City of Miami Beach
Last Completed Item Reviews Across All Submittals

Permit Type: Building - Commercial **Work Class:** Alteration (w/o Phased) **Application Date:** 05/22/2020 **Status:** Approved
Address: 235 WASHINGTON AVE **Permit:** BC2013662

Re: Response to City Comments.

Sobe Hostel
235 Washington Ave.
Miami Beach, Florida

PROP. FA LEVEL 1, 2 & ROOF

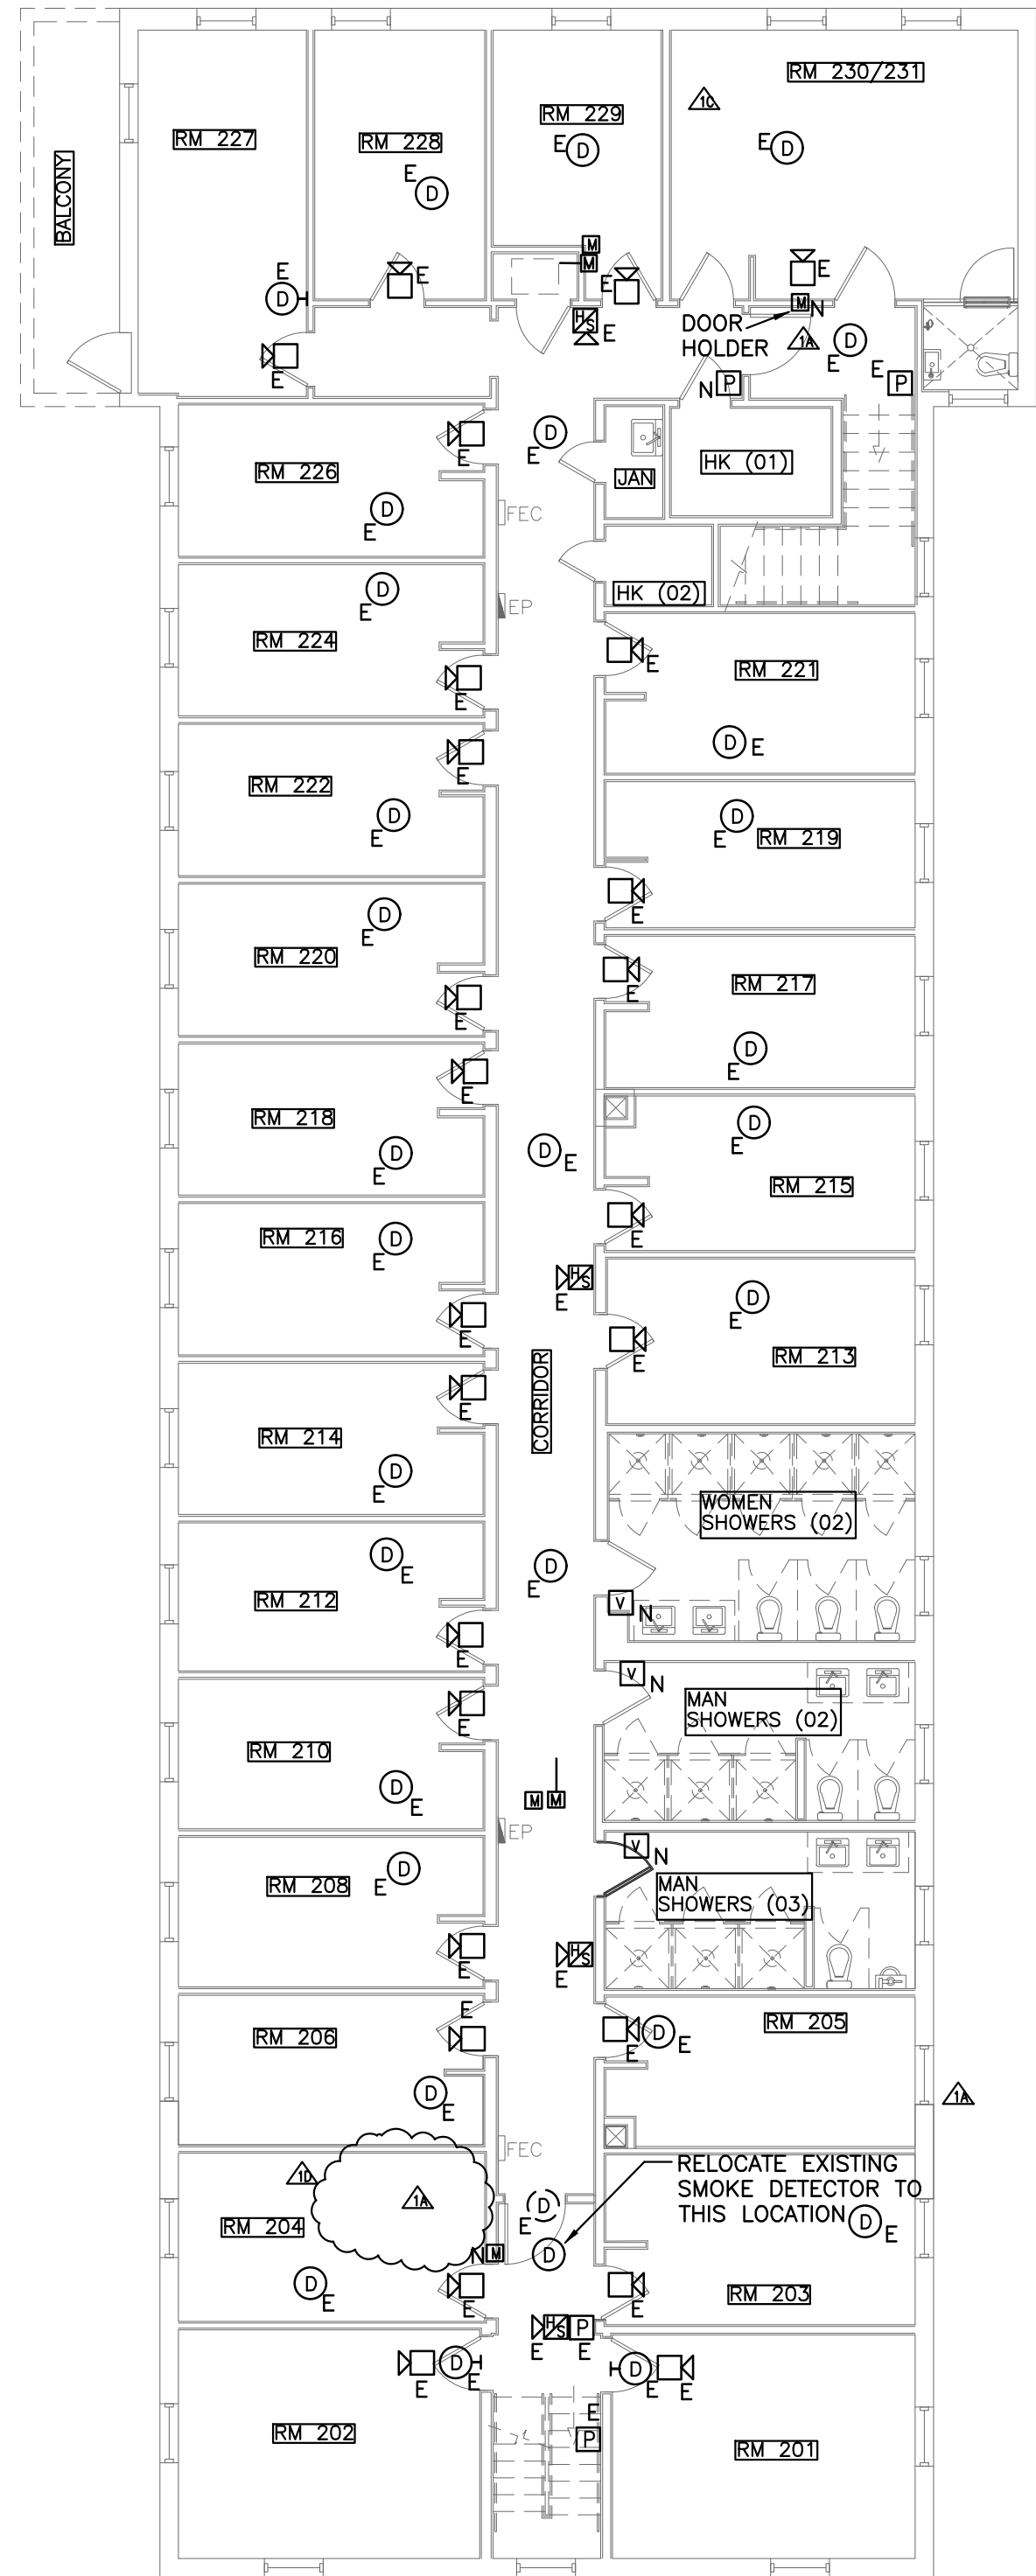
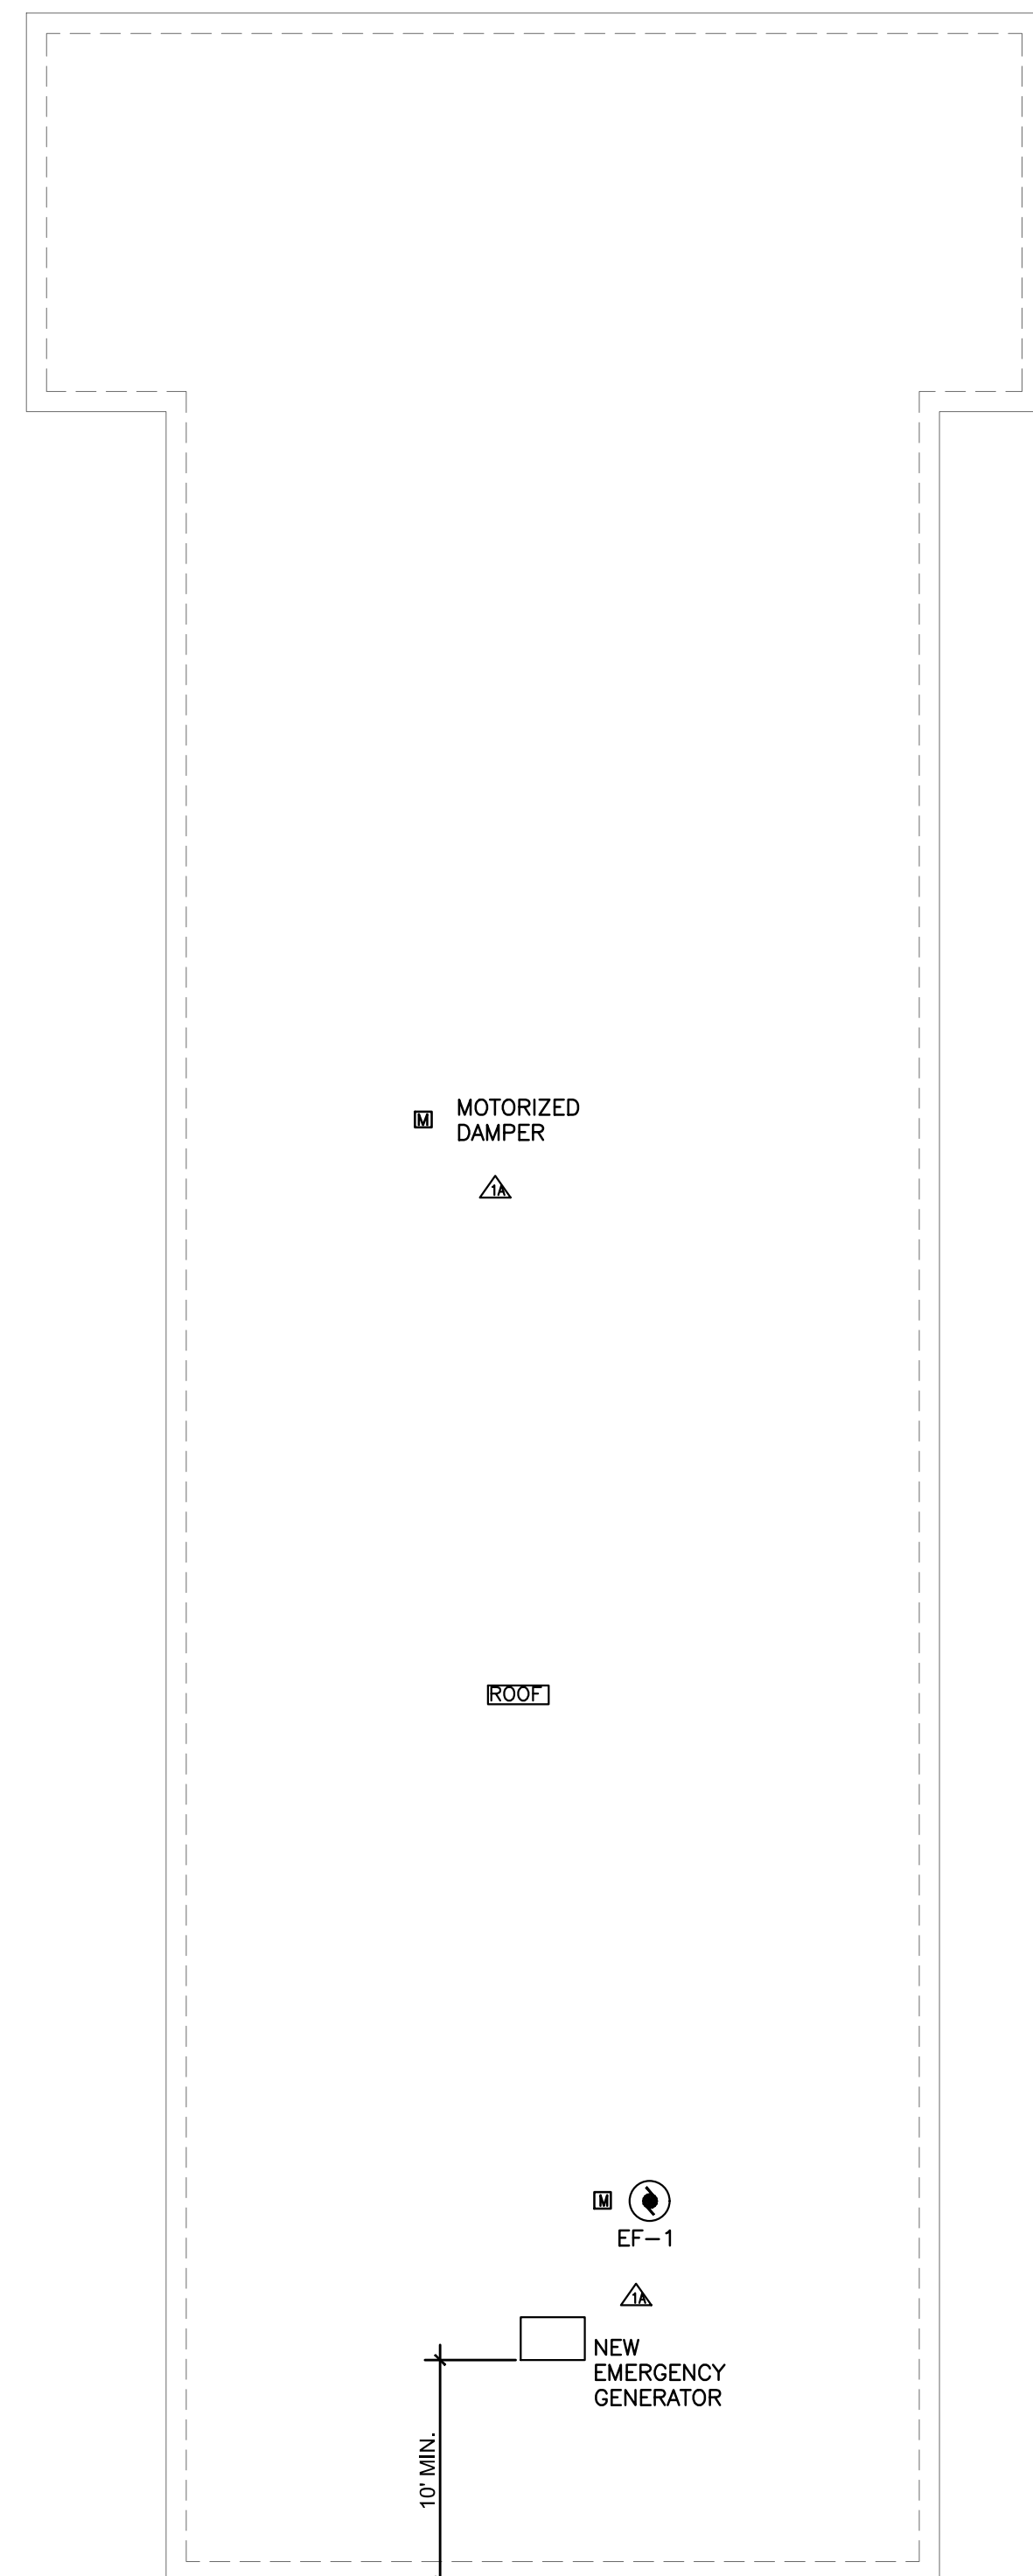
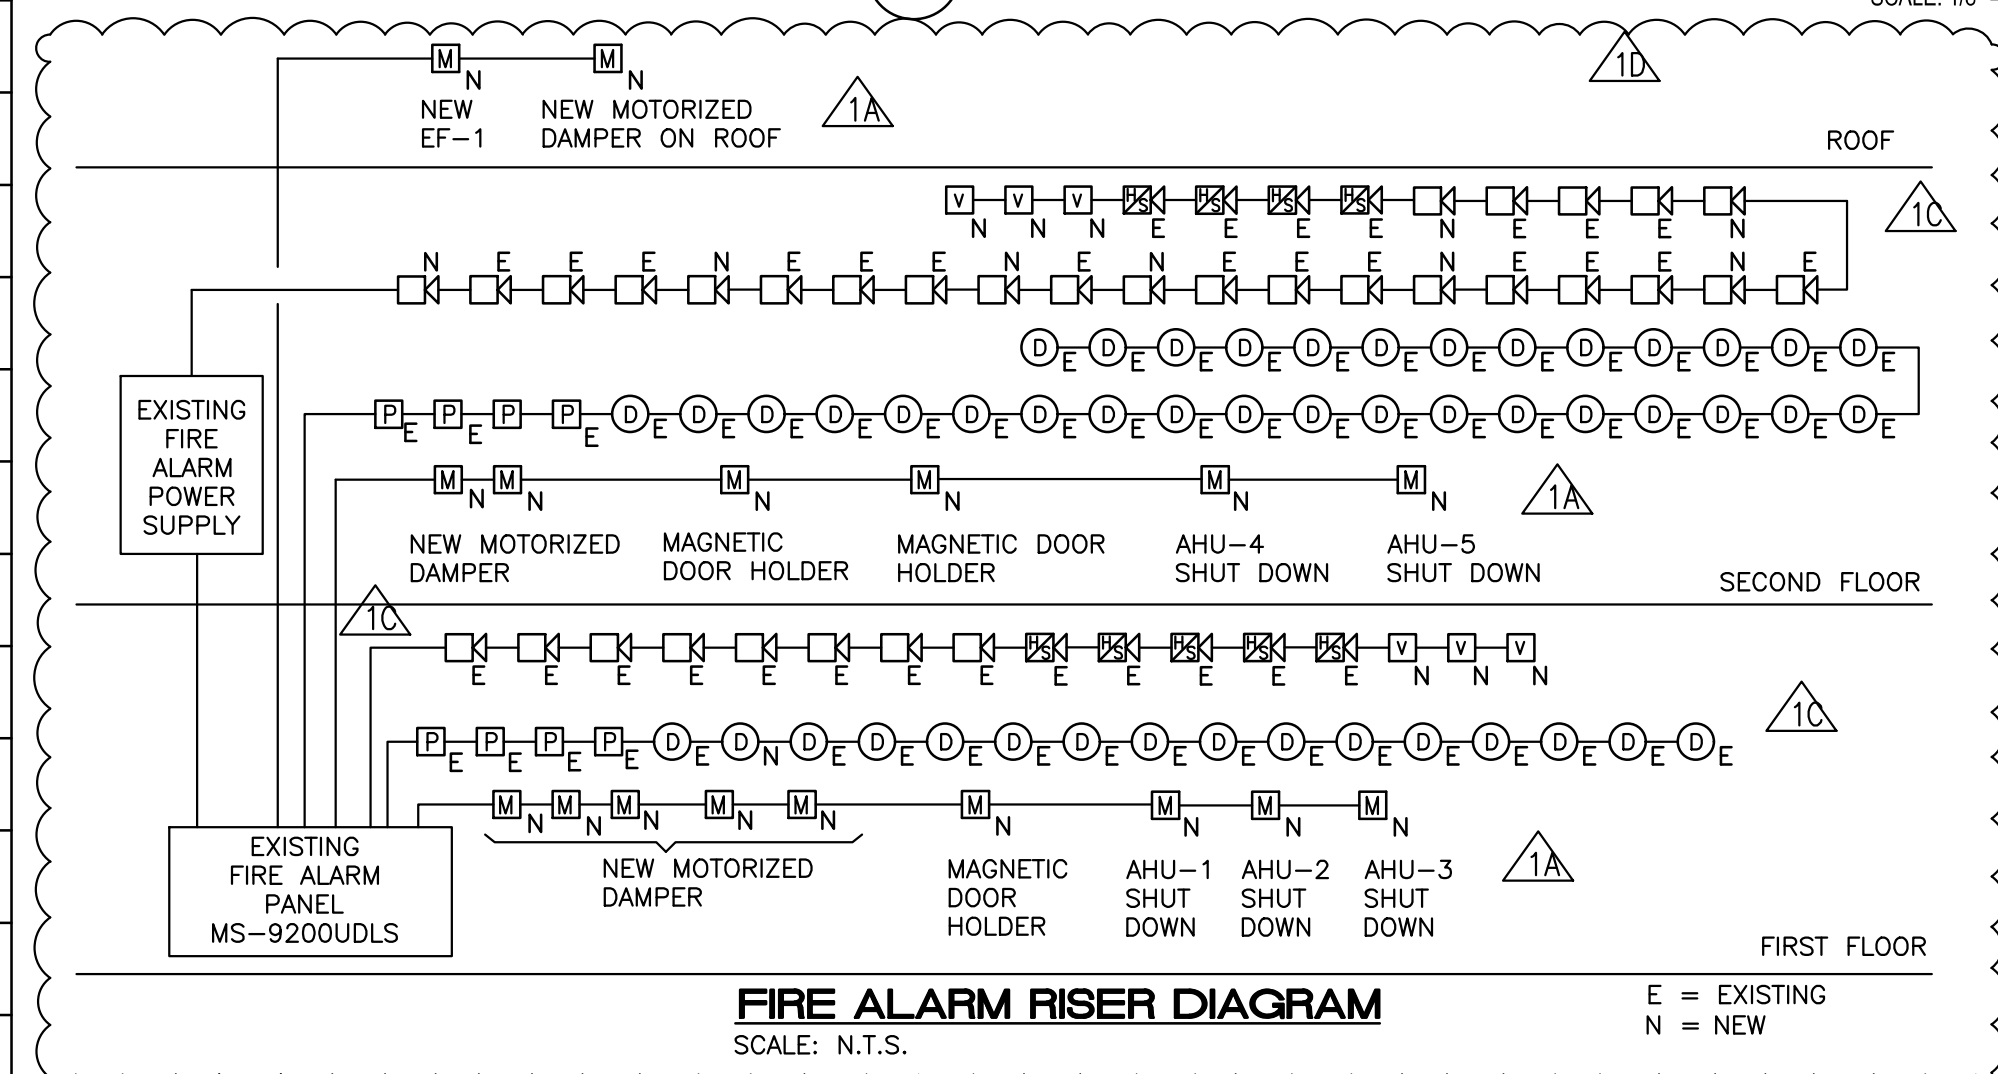
Note for reviewer: Plans state contractor shall provide fire alarm shop drawings

KKAID Response: Refer to existing FA device locations on sheet FA101
